# Road Safety Audit Review

VT 15 and East Hill Rd, Wolcott

September 23, 2020

Vermont Agency of Transportation  
Operations & Safety Bureau

## Targeted Enforcement Concept

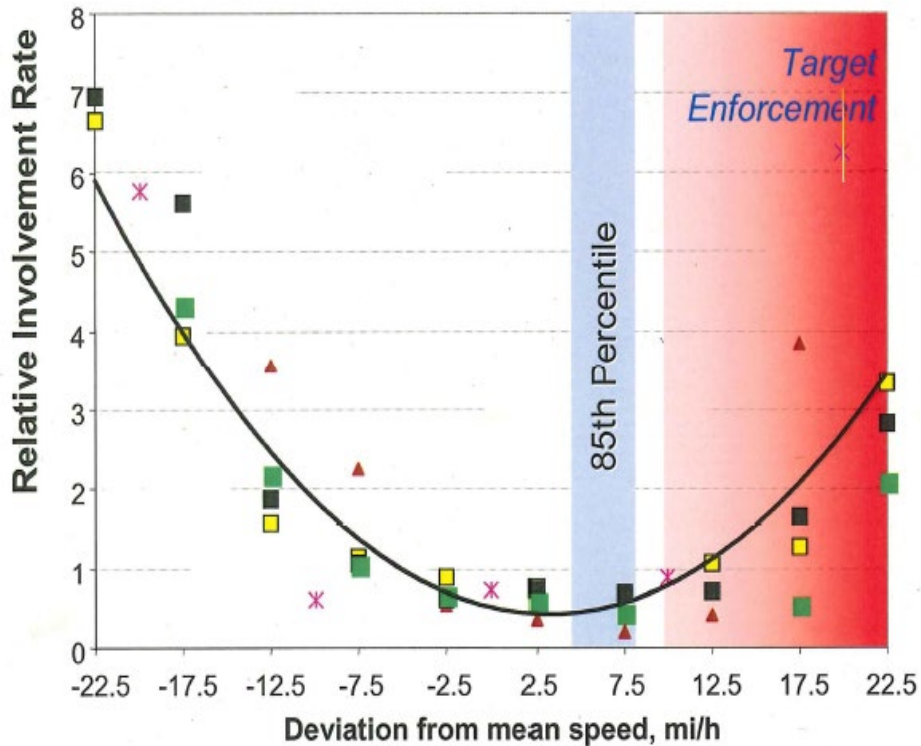
- Consider conducting recurring speed limit enforcement campaigns for the high-risk drivers (as per the discussion below, target drivers at or above 54 mph).

In doing this, consider the following concept suggested by the National Highway Traffic Safety Administration (NHTSA). As shown in the next graph, the crash involvement rate increases as traveling speeds deviate from the 85<sup>th</sup> percentile speed. This means that targeting motorists that are traveling above the 85<sup>th</sup> percentile speed will apprehend motorists that are more likely to cause a crash. Crash involvement starts to increase more drastically 5 mph above the 85<sup>th</sup> percentile speed or around the 90<sup>th</sup> percentile speed.

Applying this concept to this section of VT 15 means that the focus should be put on vehicles that are traveling at or above 54 mph (5 mph above the 85<sup>th</sup> percentile).

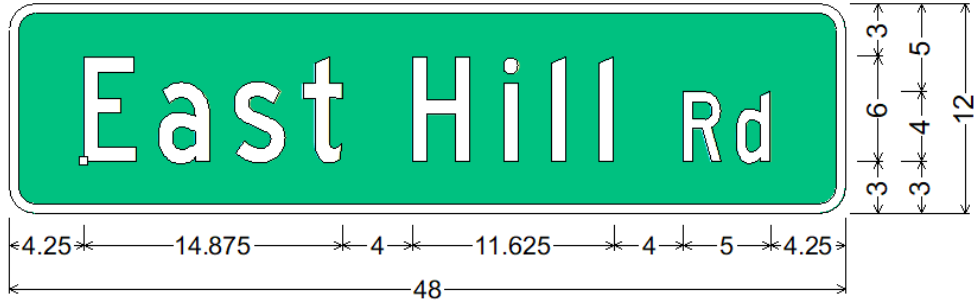
Residents use the guardrail as a guide to turn into East Hill Rd at night. Because many of the reflectors on the guardrail have fallen off, making turns into East Hill Rd when it is dark or when it is hard to see the intersection has been reported to be more difficult.

District 8 received a similar complaint concerning missing reflectors in fall 2019. District 8 inspected the guardrail sections in October 2019 and found a few triangular reflectors missing which they replace along with two green and one blue post reflectors.

- Consider inspecting the guardrail sections (District & LCPC) and replacing (District) the reflectors inside the guardrail as needed.
- Consider (VTrans Traffic Ops) installing delineators along the guardrail to supplement the guardrail reflectors.
- Consider (Town) refreshing the white edgeline markings around the two radii on the East Hill Rd approach.
- Consider (Town) installing an updated East Hill Rd street name sign (D3-1) per MUTCD standards.

The new sign would be bigger (48" x 12" as shown on the detail below) and more visible. The sign should be installed on two posts.
